Subject: Response to RAI No. 2994 (CP RAI #108)

SUBJECT: COMANCHE PEAK NUCLEAR POWER PLANT, UNITS 3 AND 4
DOCKET NUMBERS 52-034 AND 52-035
RESPONSE TO REQUEST FOR ADDITIONAL INFORMATION NO. 2994

Response to Request for Additional Information No. 2994 (CP RAI #108)
Question 03.08.04-1 (Public Version)

Tunnel Segment 1 including surrounding soil layers and fill beneath

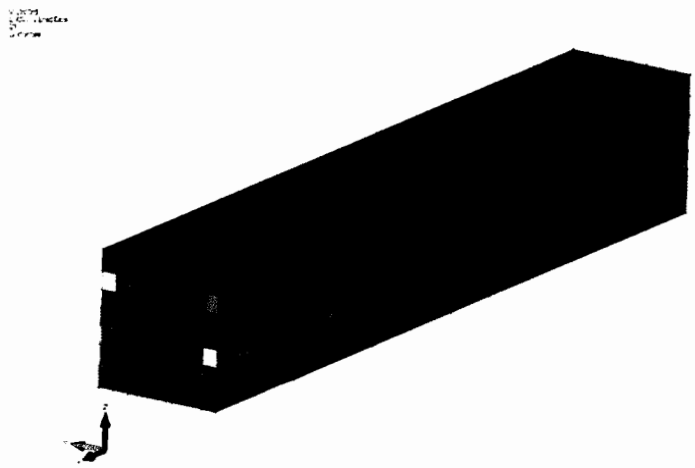
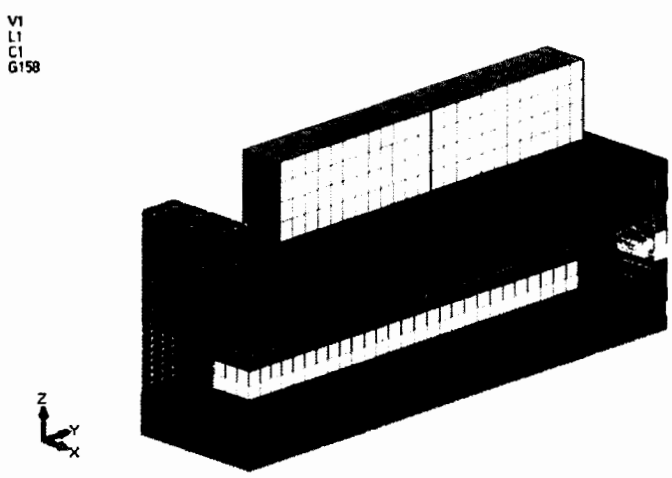
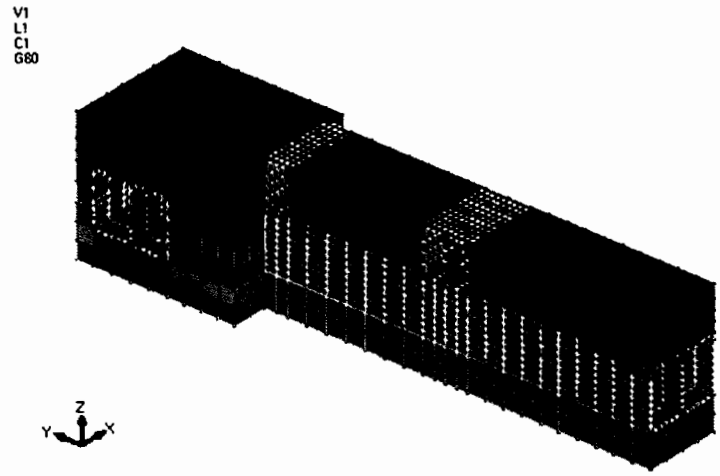
(b) Provide detailed information that shows how the static and dynamic soil pressure is calculated in accordance with ASCE 4-98.

(b) The static soil pressures are not calculated using ASCE 4-98. The static soil pressures were calculated using at-rest pressures with $K_o = 0.47$. This is the same as the at-rest pressure coefficient given in Figure 2.5.4-243 of the FSAR. The design also considered the load from the overburden pressure and the soil compaction pressure.

The seismic soil pressures are calculated directly in the SASSI analyses and are applied as equivalent static pressures in the ANSYS design model. The equivalent static seismic soil pressures applied in the ANSYS design model are shown to be conservative when compared to the calculated elastic solution used in ASCE 4-98 based on J.H. Wood, 1973 and the enveloped SASSI results. For calculation of the seismic soil pressures based on ASCE 4-98, the soil acceleration was taken as 1.5 times the ZPA of the spectrum at El. 782' (bottom of fill concrete) for tunnel segments 1 and 3 and 2.0 times this ZPA for tunnel segment 2. The value of C_v was taken equal to 0.99. The soil unit weight was taken as 125 pcf.
